**Conceptual Site Plan**  
**Detailed Site Plan**

**CSP-18009**  
**DSP-18032**

STAFF REPORT

SUBJECT: Conceptual Site Plan CSP-18009  
Detailed Site Plan DSP-18032  
Landover Crossing Shopping Center

# OVERALL DETAILED SITE PLAN

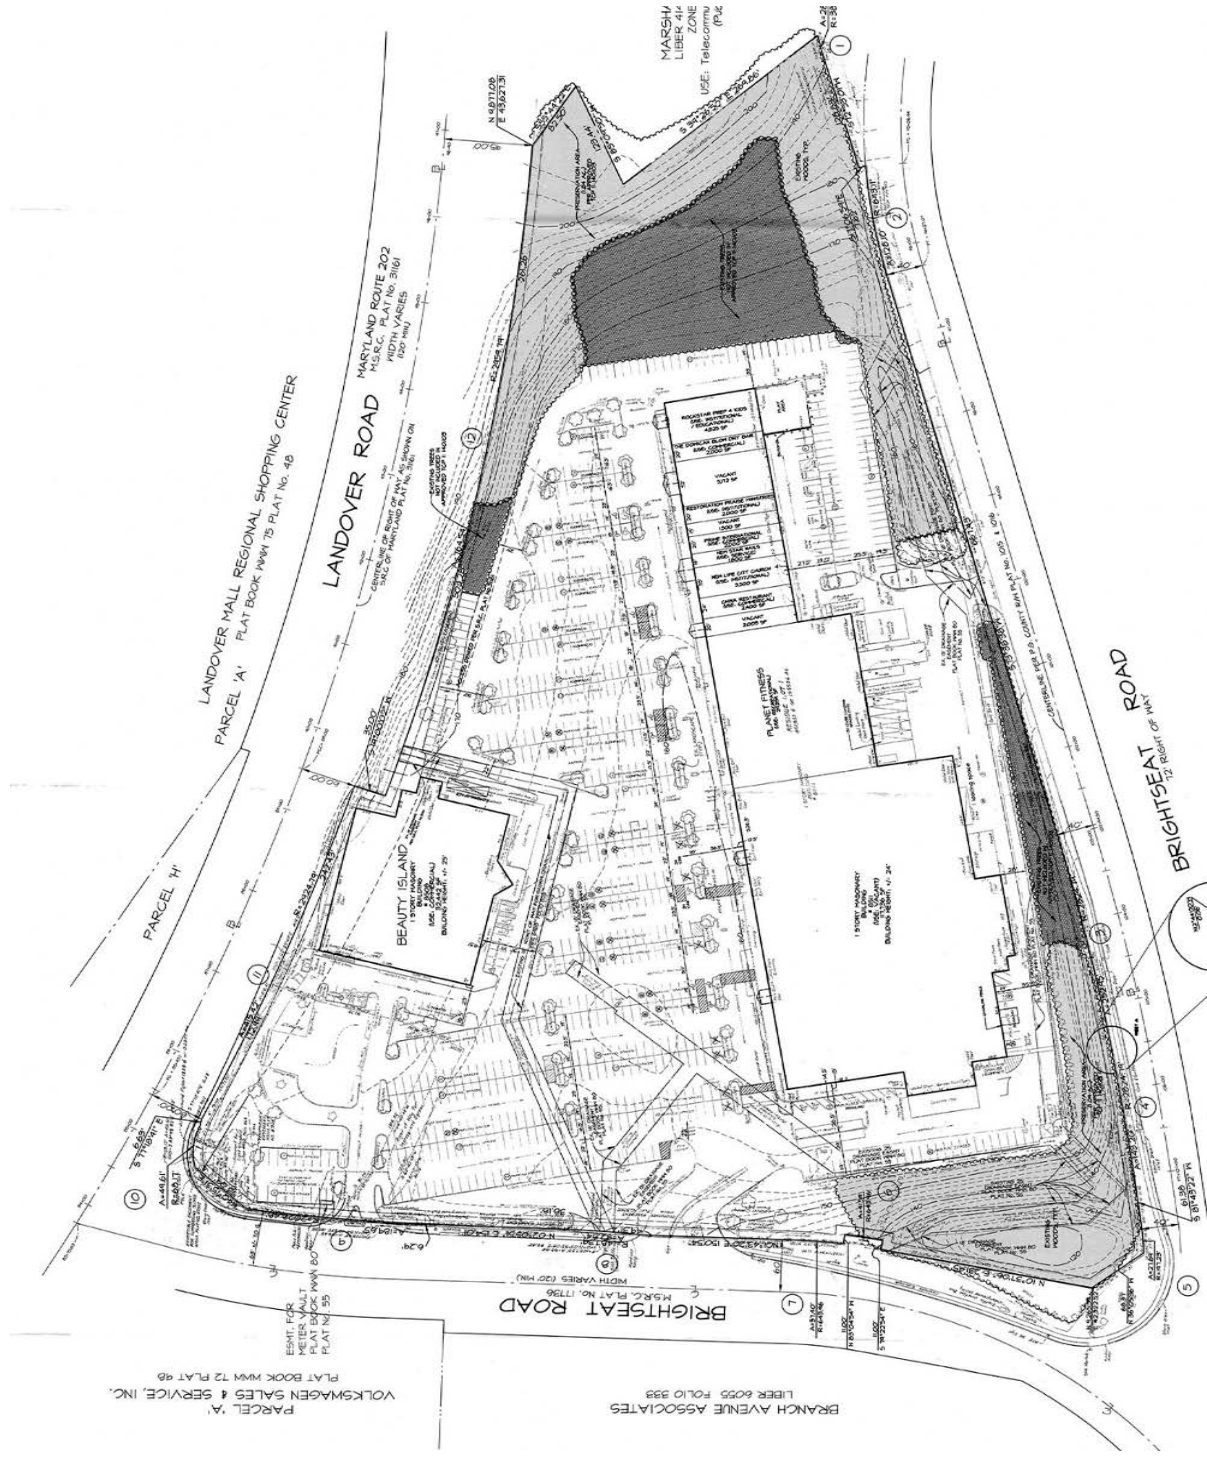
**Notes:** \*The total square footage is shown incorrectly on the plan as 206,537 and the applicant indicated the correct number for the overall integrated shopping center is 177,125, consistent with the prior use and occupancy permit. Therefore, a condition has been included in the Recommendation section of this report to provide the correct GFA of the overall integrated shopping center in the general notes and on the plan where appropriate. In addition, it is noted that the plan does not provide a schedule showing a breakdown of the tenant spaces and uses and their square footages which should be provided for future permitting. Therefore, a condition has been included in the Recommendation section of this report to provide a schedule of tenant uses with their square footage.

\*\*\*\*The DSP shows 728 parking spaces and 7 loading spaces; however, a parking and loading schedule has not been provided showing the type and number of spaces proposed. A condition has been added to the Recommendation section of this report requiring the applicant to revise the DSP to provide a parking and loading schedule to show the type and number of parking spaces proposed.

The FAR information is not shown and should be added to the general notes on the CSP/DSP, as conditioned herein. The FAR of the existing buildings are 0.20 based on the GFA of 177,125 square feet. However, as stated previously, this should be confirmed and should exclude basement storage areas and mechanical element areas. The existing buildings are legal, and were developed prior to the property being zoned M-X-T.

Trash facilities appear to be shown on the southern and western sides of the site and are appropriately screened. However, these are not clearly labeled on the plan. Therefore, a condition has been included in the Recommendation section of this report requiring the applicant to clearly label these locations on the plan, and screen or enclose them with an evergreen screen, or sight-tight fence, that is compatible with the building.

- a. Provide the existing floor area ratio information in the general notes on the DSP.
    - b. Provide the correct square footage of the integrated shopping center on the DSP where appropriate.

- c. Provide a parking and loading schedule to show the type and number of required and proposed parking and loading spaces, in accordance with Sections 27-574 and 27-583 of the Prince George's County Zoning Ordinance.

- d. Provide a schedule of tenant spaces and uses including their square footage, which should exclude those portions of the basement that are used exclusively for storage or other areas used exclusively for mechanical elements.

- g. Provide the plan's applicable record plat reference, NLP 145-90, in the general notes.
